Troy Schools District

**BP#3A Smith Middle School – Foundations and Steel -
Addendum #3
February 12th, 2024**

Addendum #3 Bidder Clarifications

S1.3E

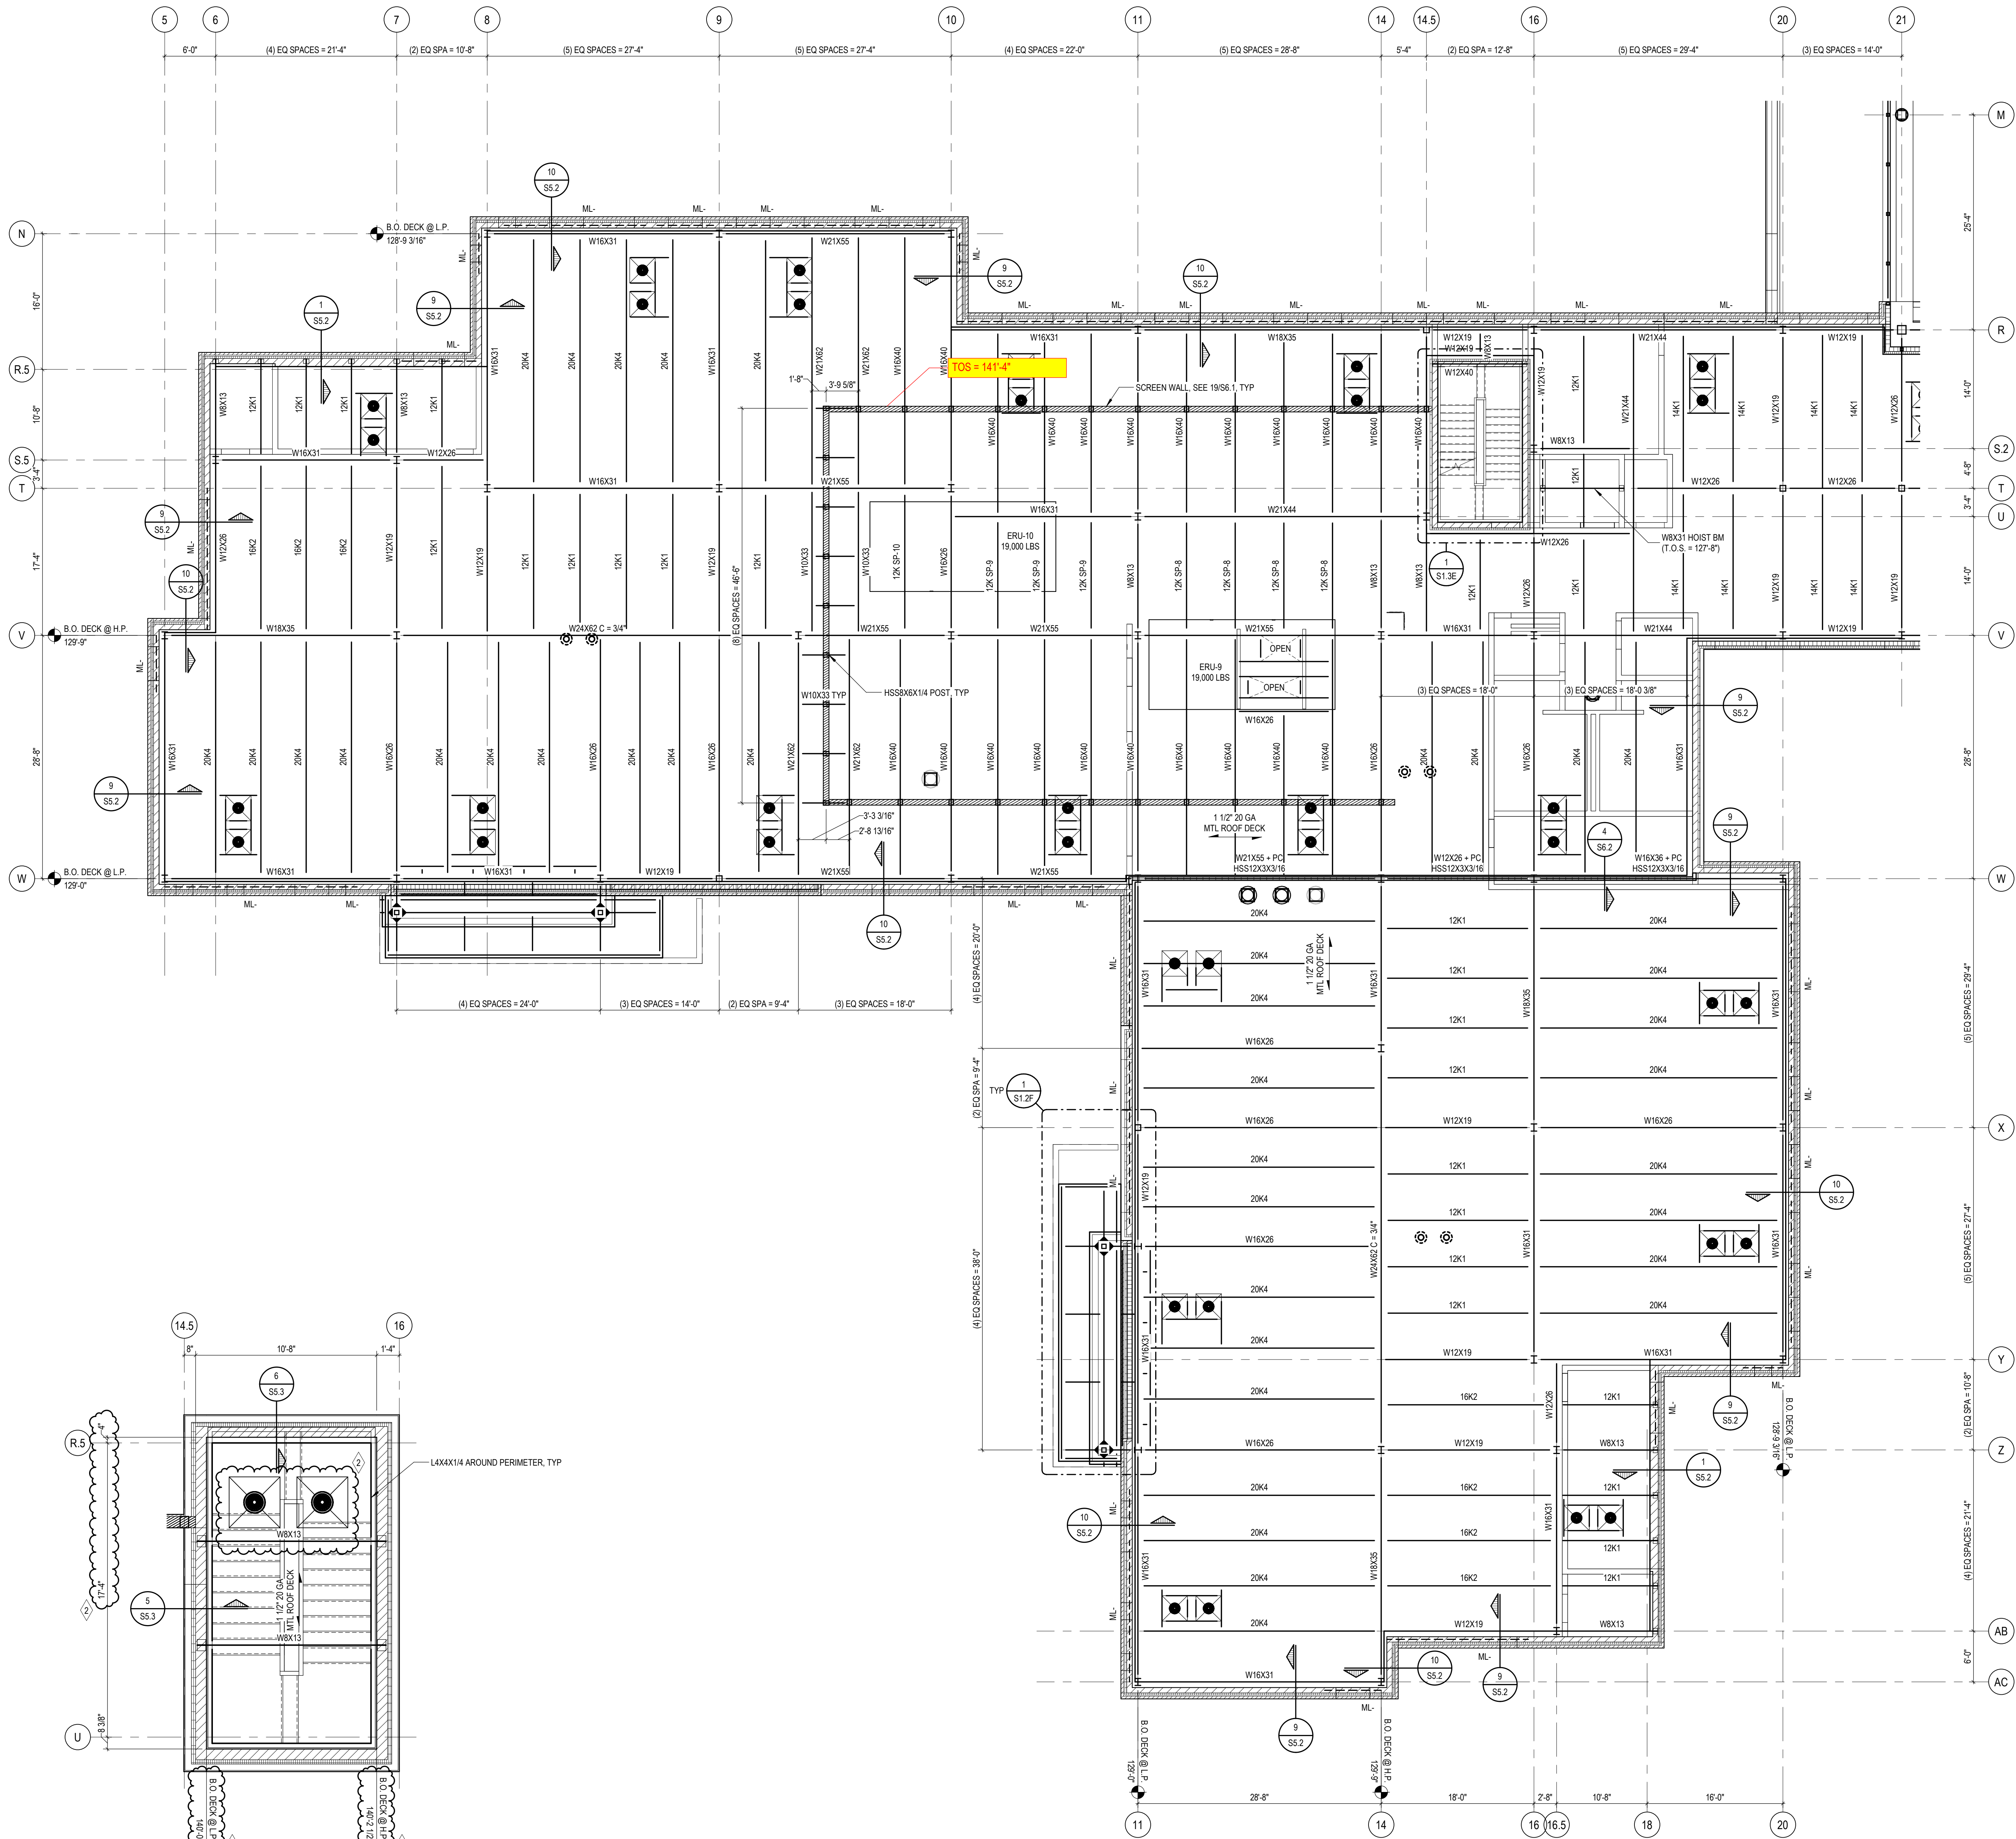
Q: Please verify roof screen wall height relative to top of deck/top of screen wall (ref. section 19/S6.1). Need to know how long the screen wall post will be +/- roof slope.

A: See attached PDF with the screen wall T.O.S. Friday. Screenwall post length will verify depending on location and roof steel slope, top of screenwall elevation is constant and as noted on the markup.
